**Subject: Voluntary Investigation and Remediation Plan  
BWAY Drum Site (HSI #10731)  
1601 Valdosta Highway, Tax Parcel No. 063-026  
Homerville, Clinch County, Georgia**

**Voluntary Investigation and  
Remediation Plan  
BWAY Drum Site  
Homerville, Georgia  
HSI Site No. 10731**

**Subject: Additional Response to EPD 8/23/10 Correspondence  
Regarding the VRP Application for  
BWAY Drum Site (HSI #10731)  
1601 Valdosta Highway, Tax Parcel No. 063-026  
Homerville, Clinch County, Georgia**

**CURRENT GROUND WATER CONCENTRATIONS WITH CROSS-SECTION LOCATIONS**  
VOLUNTARY REMEDIATION PLAN  
BWAY CORPORATION (HSI # 10731)  
HOMERVILLE, CLINCH COUNTY, GEORGIA

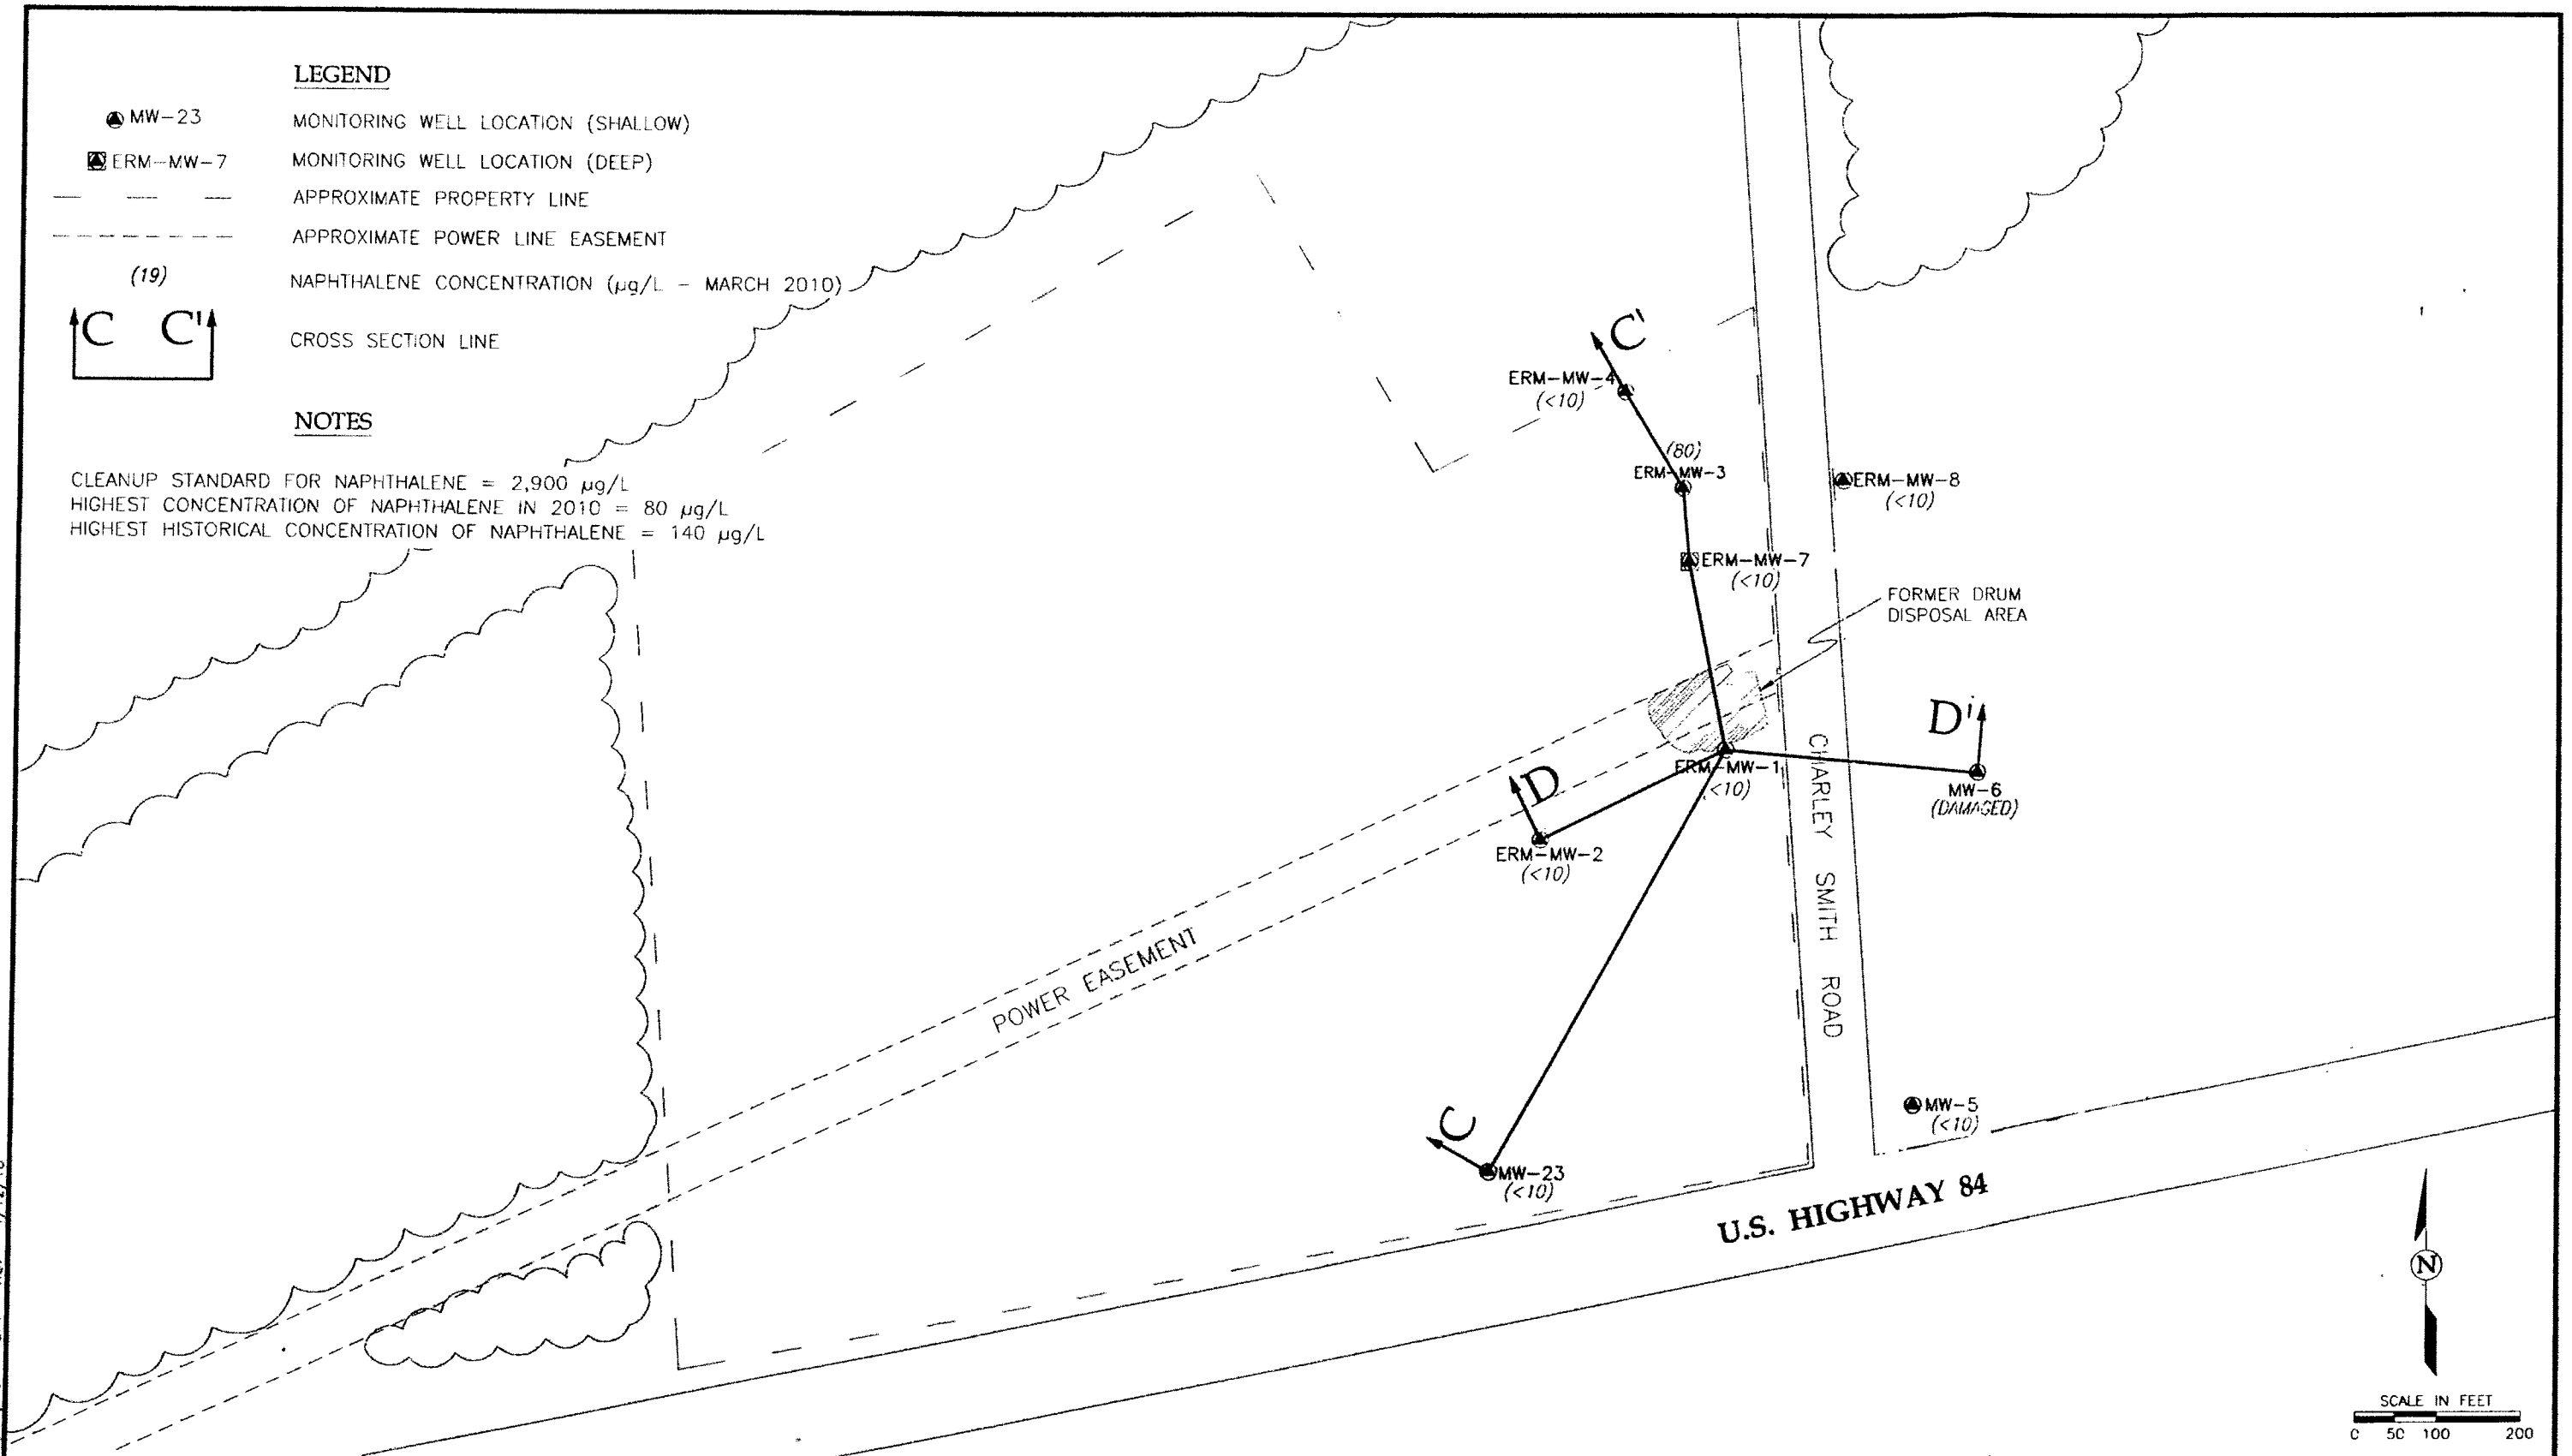
*Comment #1, Regarding the Application/Checklist: The outlines shown for the qualifying property tax parcel on Figure 1-3 (Receptor Map) and the tax parcel map provided in Appendix B of the VRP do not correspond with the property outlines shown on Figures 2-1, 3-1, 3-2, and 3-5. The property boundaries for the qualifying property must be accurately shown on all applicable figures. Furthermore, please indicate whether the Parcel 063-041 is to be included as a qualifying property as delineation location for the groundwater plume are included on this parcel.*

Maps have been revised to show that the intent is to perform groundwater delineation within Tax Parcel 063-026 (i.e. 063-041 is not considered a qualifying property). A revised version of Appendix B - Figure 1, the Tax Parcel Map, is attached to show the correct qualifying property boundaries. A revised version of Figure 3-1 is also attached to show that the property boundary for Tax Parcel 063-041 is not intended to be part of the VRP qualifying property. Additionally, figures submitted in future reports will be revised to show the correct qualifying property boundaries.

**RECEPTOR MAP**  
VOLUNTARY REMEDIATION PLAN - REVISION 1  
BWAY CORPORATION (HSI # 10731)  
HOMERVILLE, CLINCH COUNTY, GEORGIA

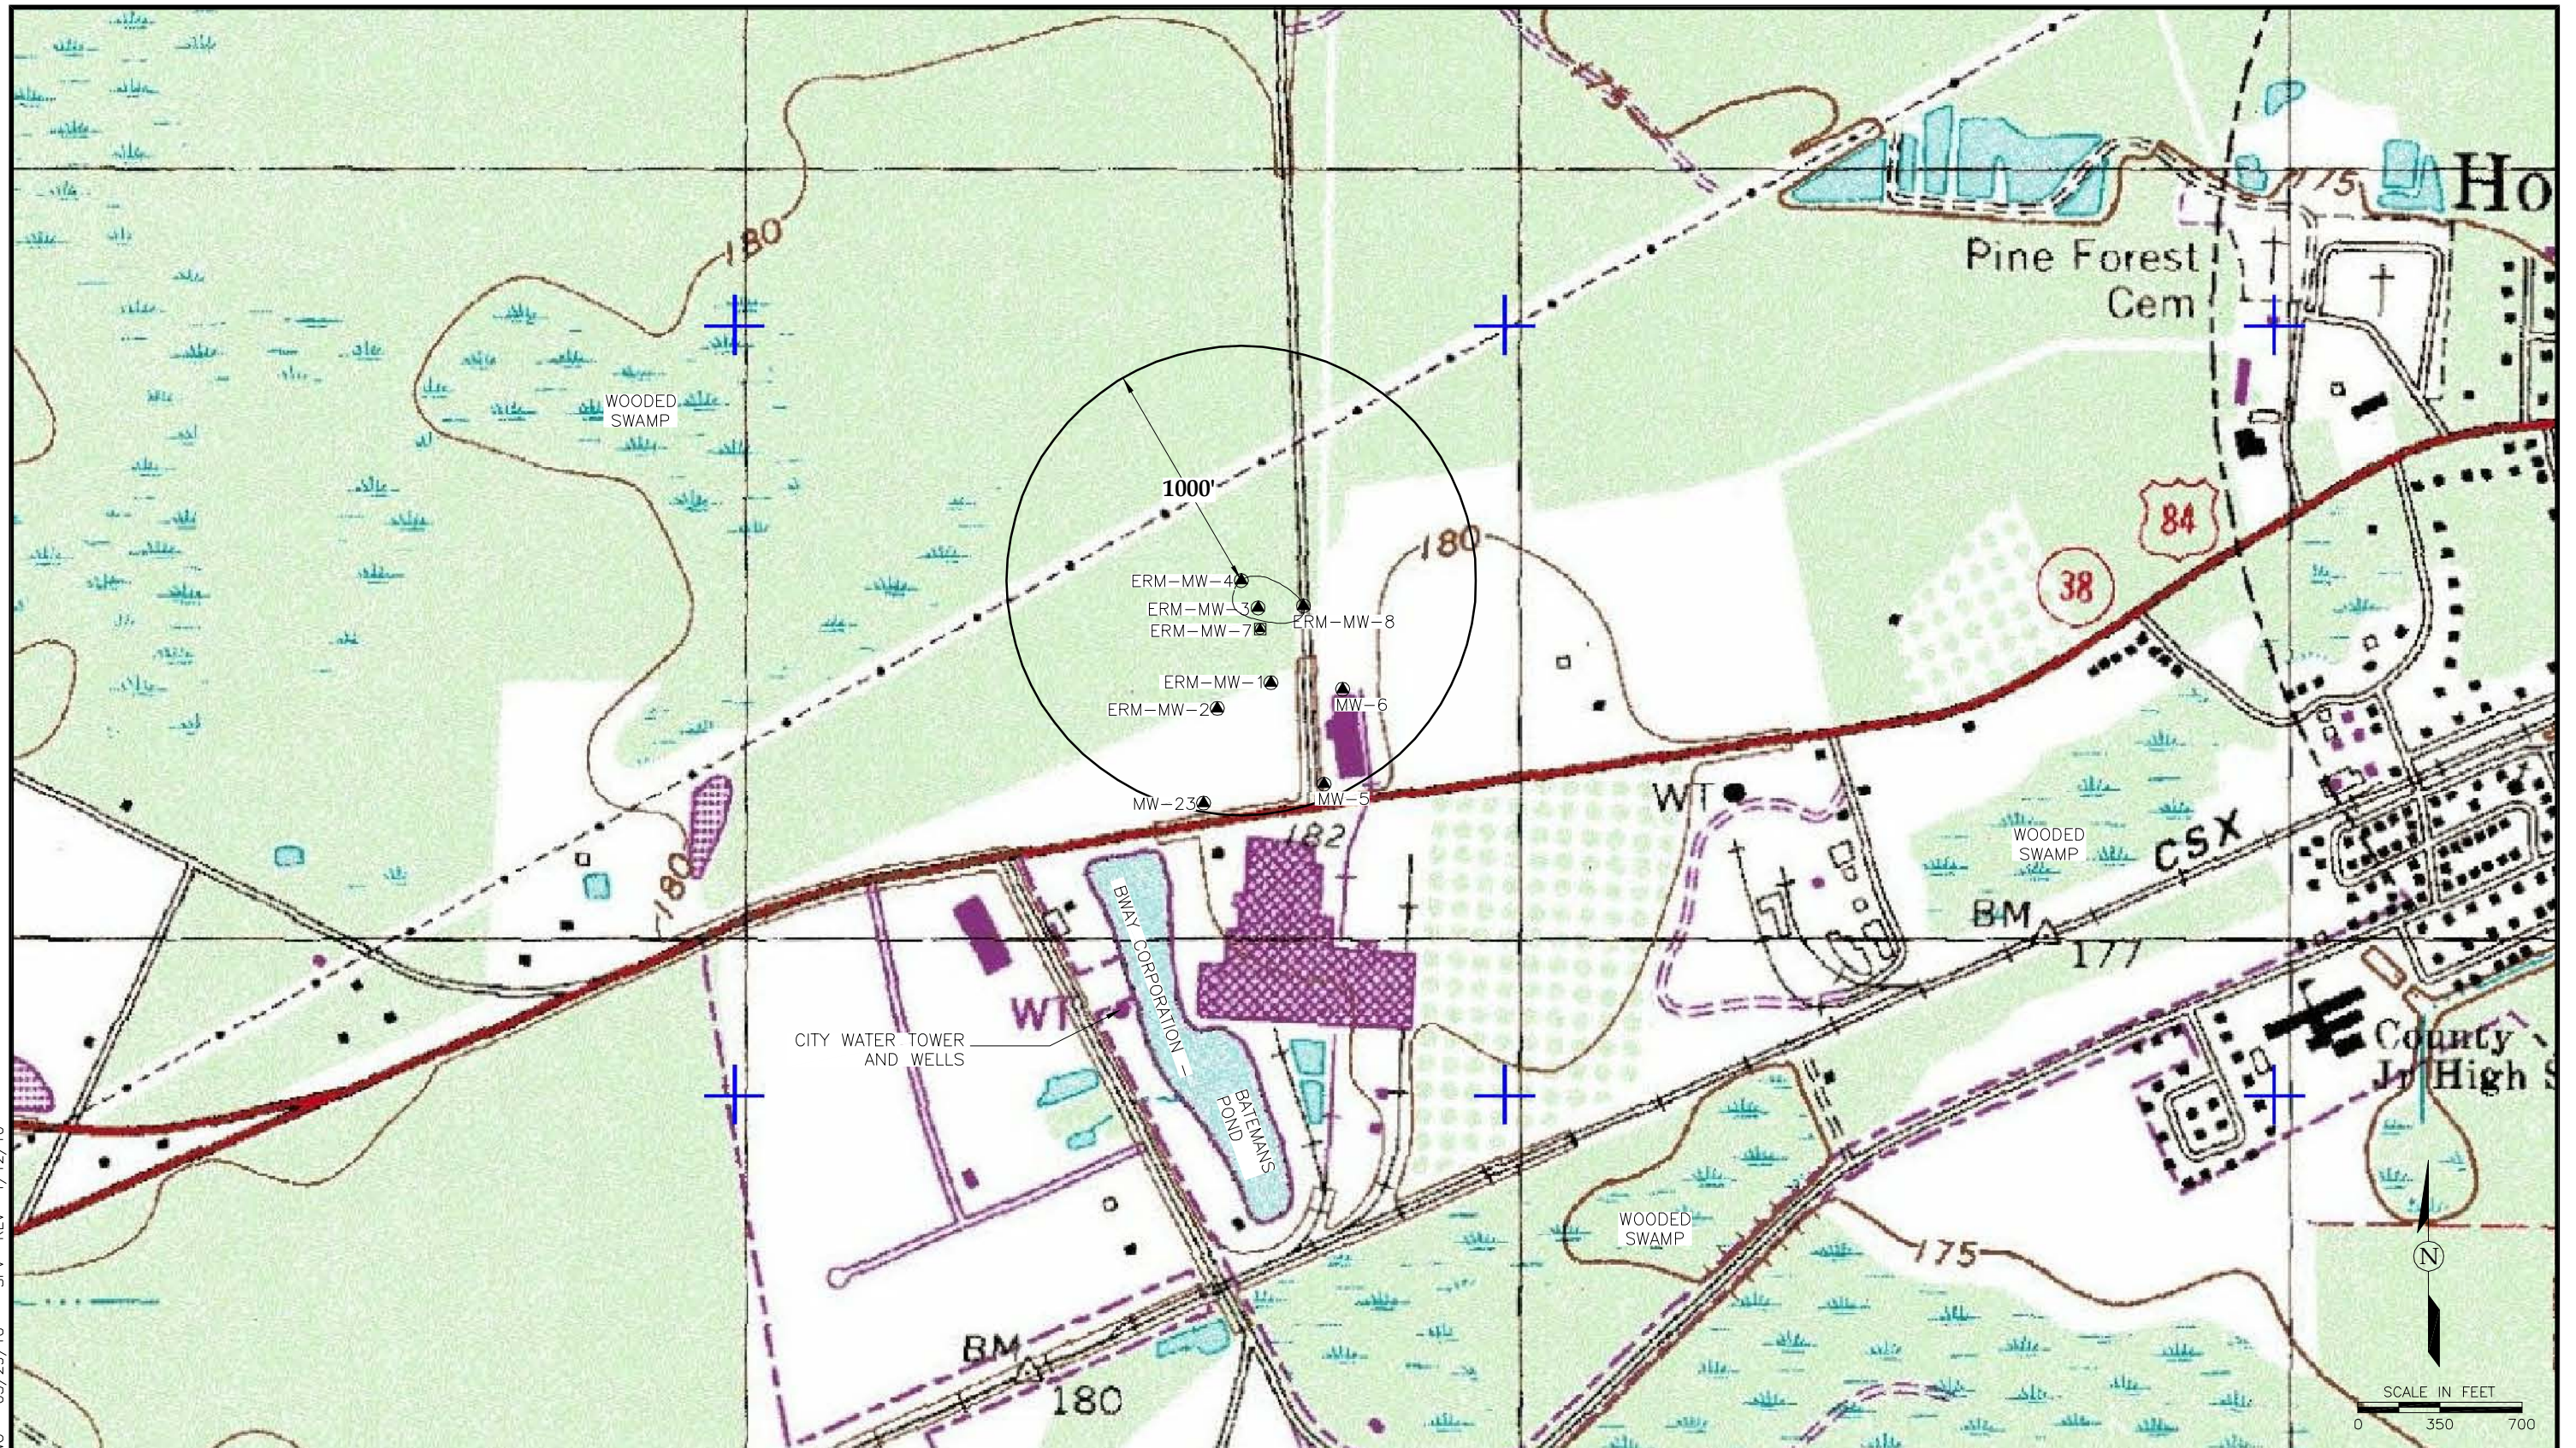
**Comment 1:** The outlines shown for the qualifying property tax parcel on Figure 1-3 (Receptor Map) and the tax parcel map provided in Appendix B of the VRP do not correspond with the property outlines shown on Figures 2-2, 3-1, 3-2, and 3-5. The property boundaries for the qualifying property must be accurately shown on all applicable figures. Furthermore, please indicate whether the Parcel 063-041 is to be included as a qualifying property as delineation locations for the groundwater plume are included on this parcel.
